Authors' response (Comment, Response, Change); page and line numbers refer to the marked-up revised manuscript.

Response to Reviewer #1

Figure 1. Multiple interdependent climate controls of water temperature; Q^* is the sum of K and L ; Q_a also small advective fluxes due to inflow/outflow into river, hyporheic exchange, groundwater (not shown); [adapted from Caissie (2006) and Hannah et al. (2008)].

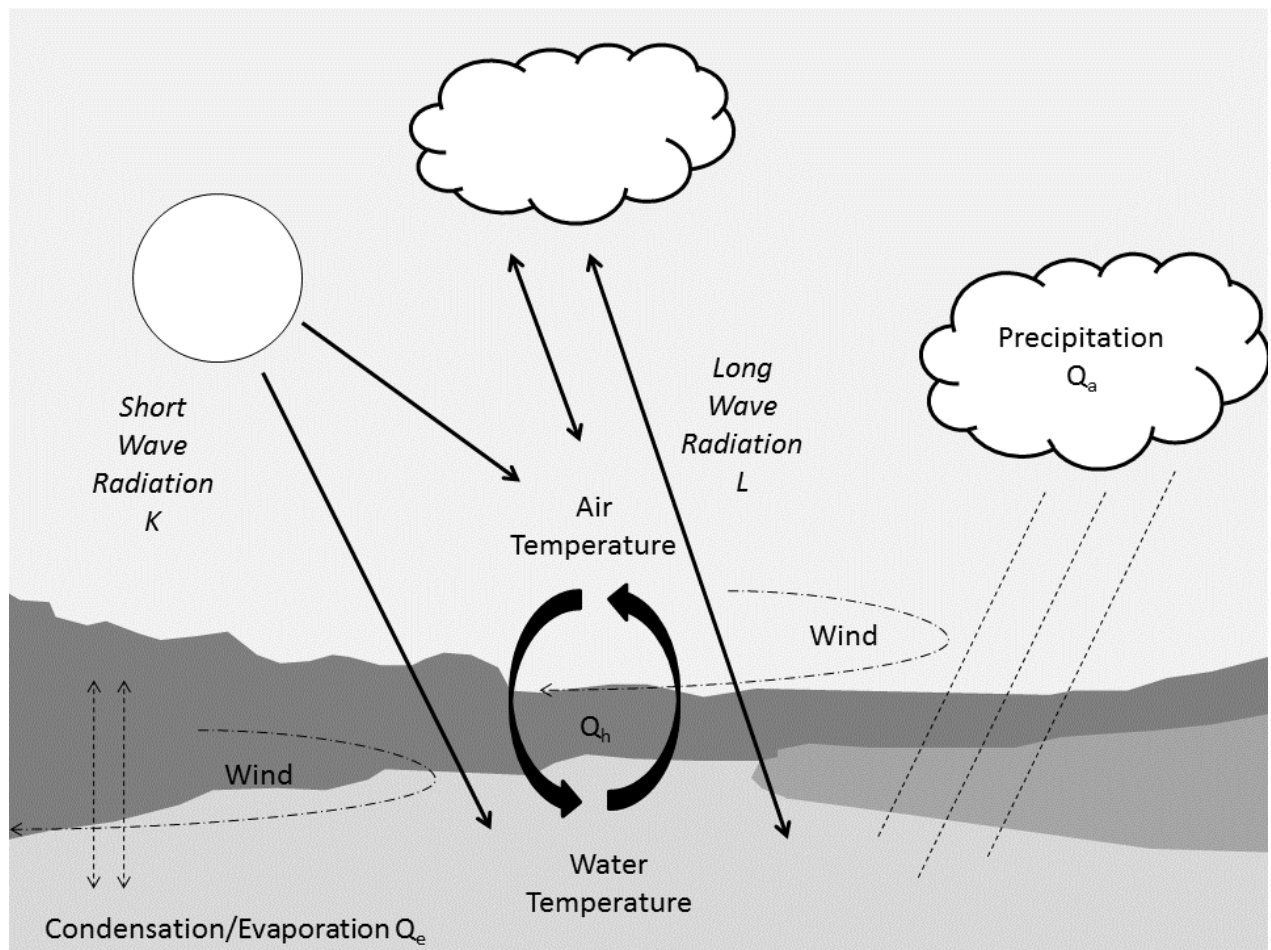
Comment #3: P.3,l.21, figure 1: perhaps add the symbols from equation 1 to highlight more which process is related to which heat flux.

Response #3: Figure revised as suggested.

Change #3: New figure inserted and caption edited accordingly.

2 Figure 23. Location map of the study sites.

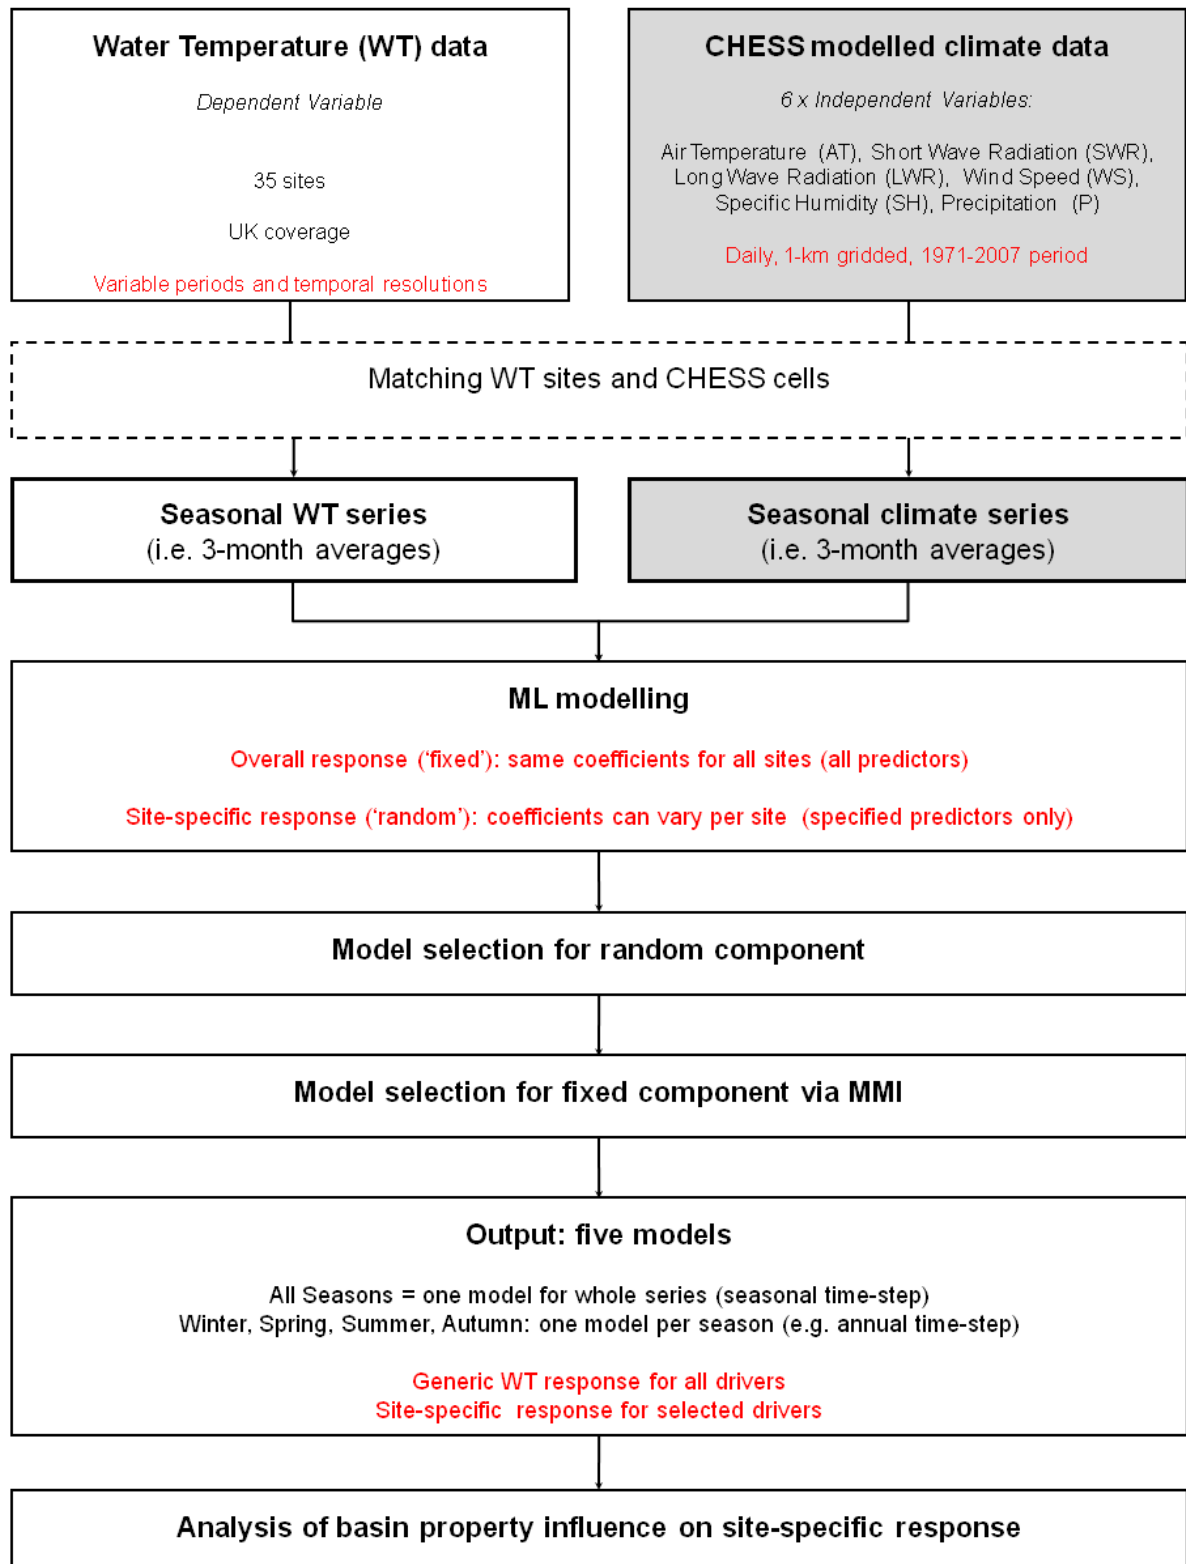
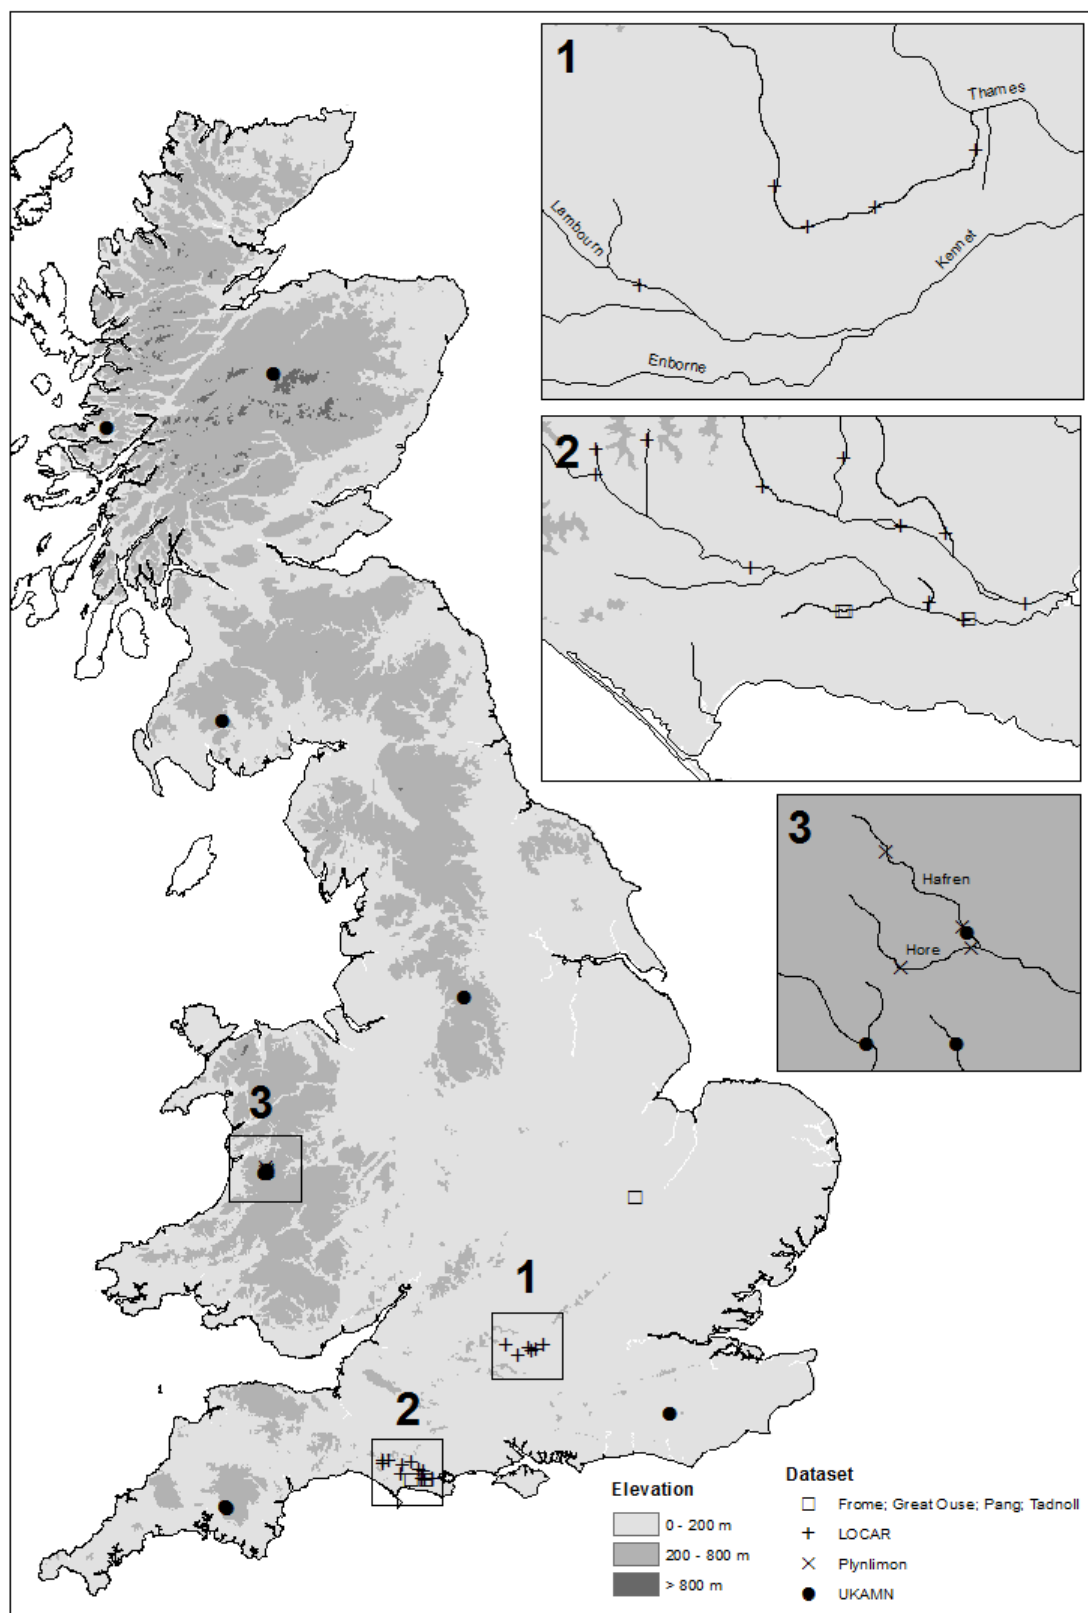
Comment #8: P.5,L.20: figure numbering wrong: figure 3 referred to before figure 2. Please also make this figure a bit more informative. Provide basin/river names and potentially include elevation information. Please also clarify why some observation sites are far from streams (e.g. in insets 2 and 3).

Response #8: Current Fig 3 was meant to be Fig 2, and vice-versa, so was correctly referred to first. We swapped figures 2 and 3, and corrected numbering accordingly. All sites are on streams, but we only had access to a simplified river shapefile, which did not show smaller streams. Smaller stream have been added, as well as elevation ranges as a background. Where available, river names were added.

Change #8: Updated Fig. 2, and corresponding caption.

2 Figure 4. Plots of observed and modelled water temperature for the five models.

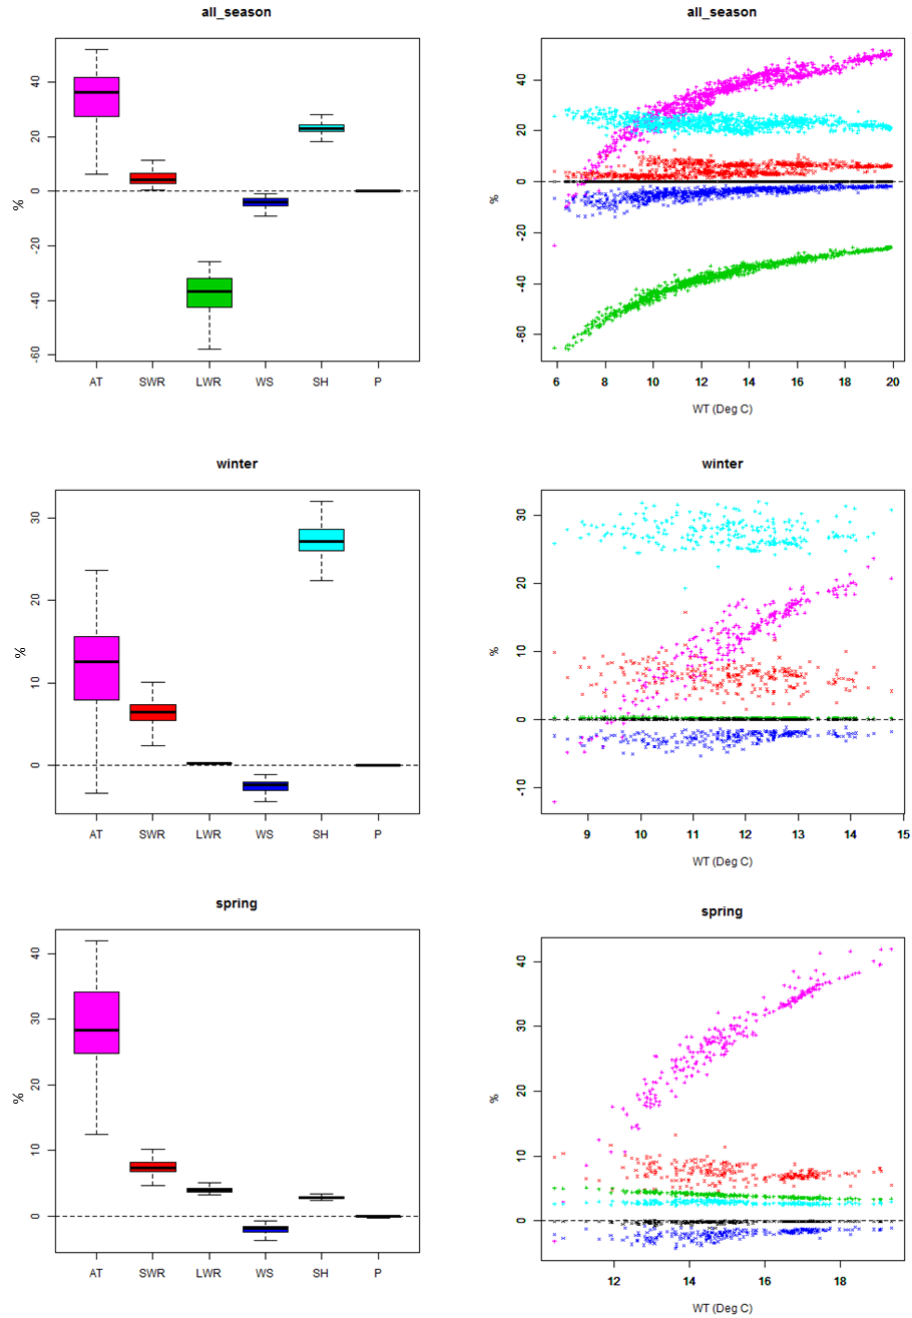
20 Comment #19: Figure 4 should be improved – it is difficult to read axes. Model fits should be
21 included.

22 Response #19: The size of the figure has been increased slightly to improve readability (figure
23 has also been edited to amend one label, which was not displayed properly). Model fits
24 (conditional R²) have been added to text. Given the conditional R² are strictly speaking
25 calculated for each model in a model set rather than for the average model (ie the average of
26 all models in a model set), we think it is more accurate to leave the reader to gauge the
27 average model fits visually than to add a mean R² to the plots (see Reviewer #1 Comment
28 #21).

29 Change #19: Figure amended. Paragraph giving conditional R² inserted (P12, L27 to P13, L2,
30 in revised manuscript).

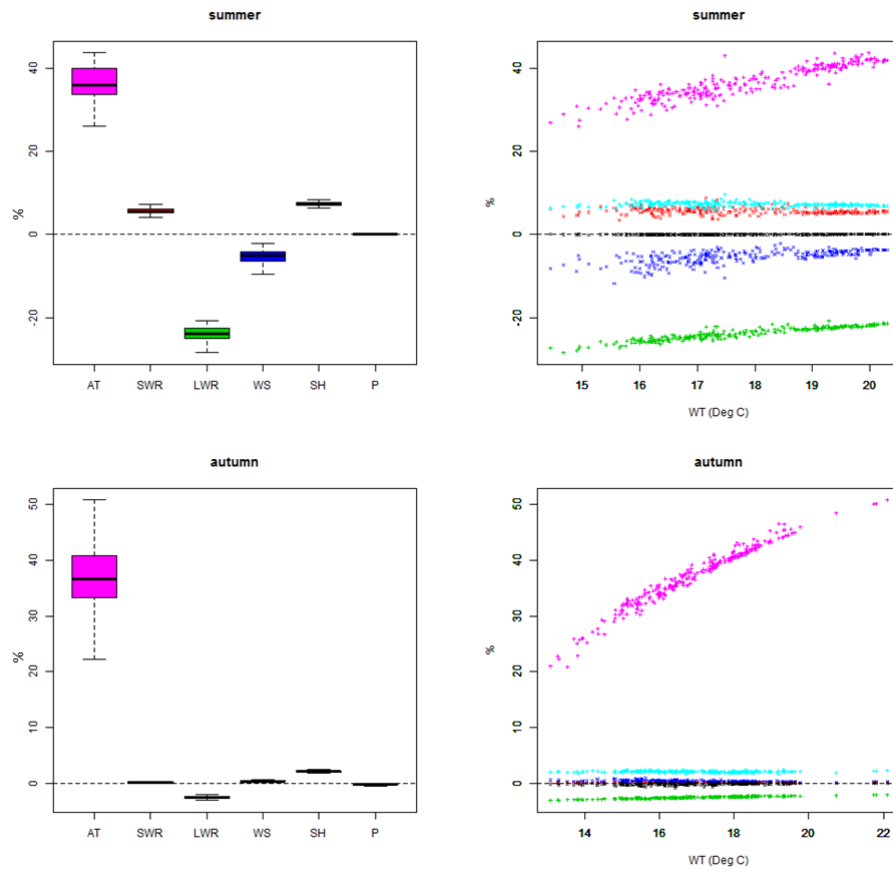
Comment #24: P.12,1.4, figure 5: please provide a unit for the y-scale in the figure. The unit of the x-scale (%) seems to be wrong here. In addition, please be more specific: % of what?

31 Comment #20: Figure 5, please label the y-axes

Response #24: The y-axis label ('%') was erroneously placed on the x-axis. Captions explain what the % are for both sets of plots (we found that trying to abbreviate the % definition to fit it as an axis label did not really improve the figures).

Change #24: Figure amended (% relocated to y-axis).

32 Response #20: The y-axis label ('%') was erroneously placed on the x-axis.

33 Change #20: Figure amended.
